CITY OF KELOWNA

MEMORANDUM

Subject: Multi-Residential Development Permit Application

APPLICATION NO. DP06-0151

PARKING LEVEL 1 FLOOR PLAN

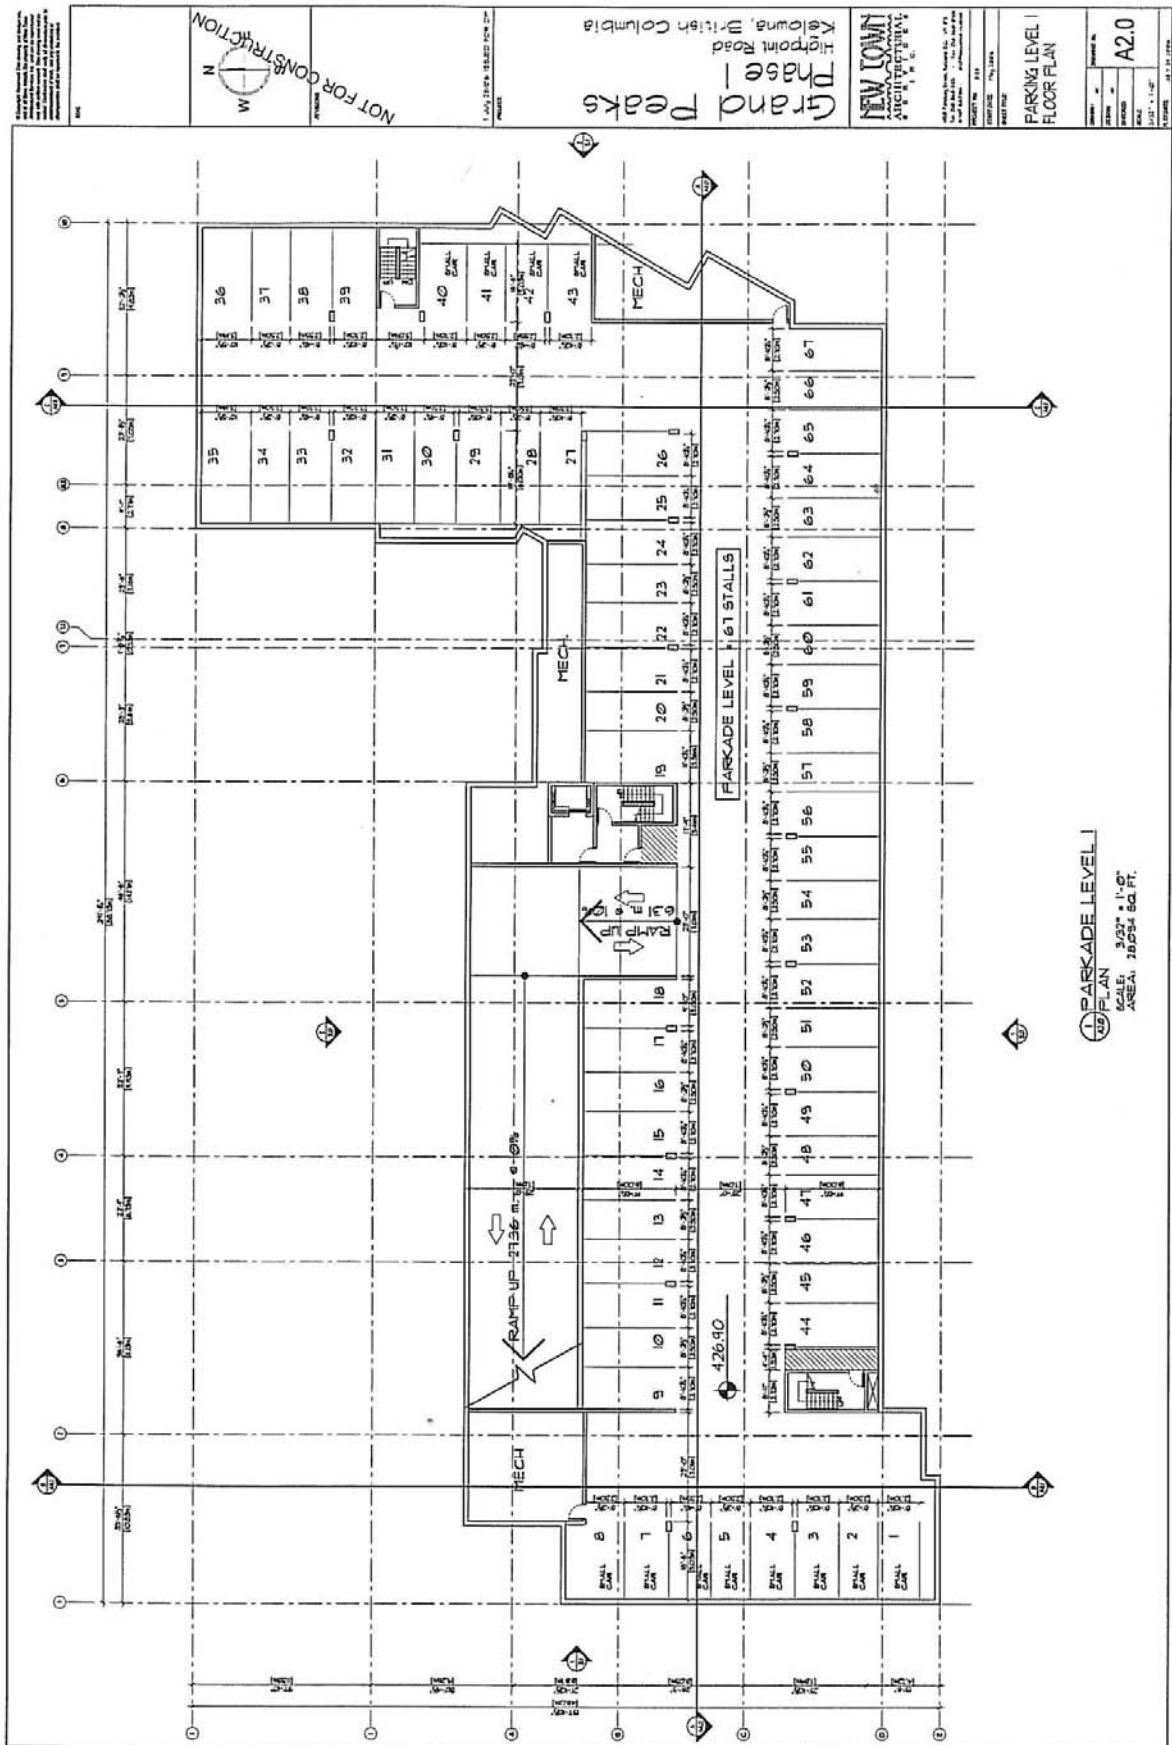
A multi-unit building on a hillside should make every effort to ensure the building is fully accessible. Level entrances and access from parking areas to the building are essential. Adaptable design is highly recommended so that people who develop disabilities can easily adapt their home to accommodate the disability and visitors with disabilities can easily access the building. The mandatory guidelines from Saanich are a recommended minimum requirement. The handicapped parking stall on the first floor (2nd level parking) will present conflict with vehicles entering & leaving the parkade. Although this is further from the building entrance, the space should be moved to the south side of the parkade, next to the storage area. Handicapped spaces are not shown on level

one of the parkade and should be provided at the location of space 19. The communal roof terrace on the 4th floor is a positive feature which could be expanded to make greater use of roof space.
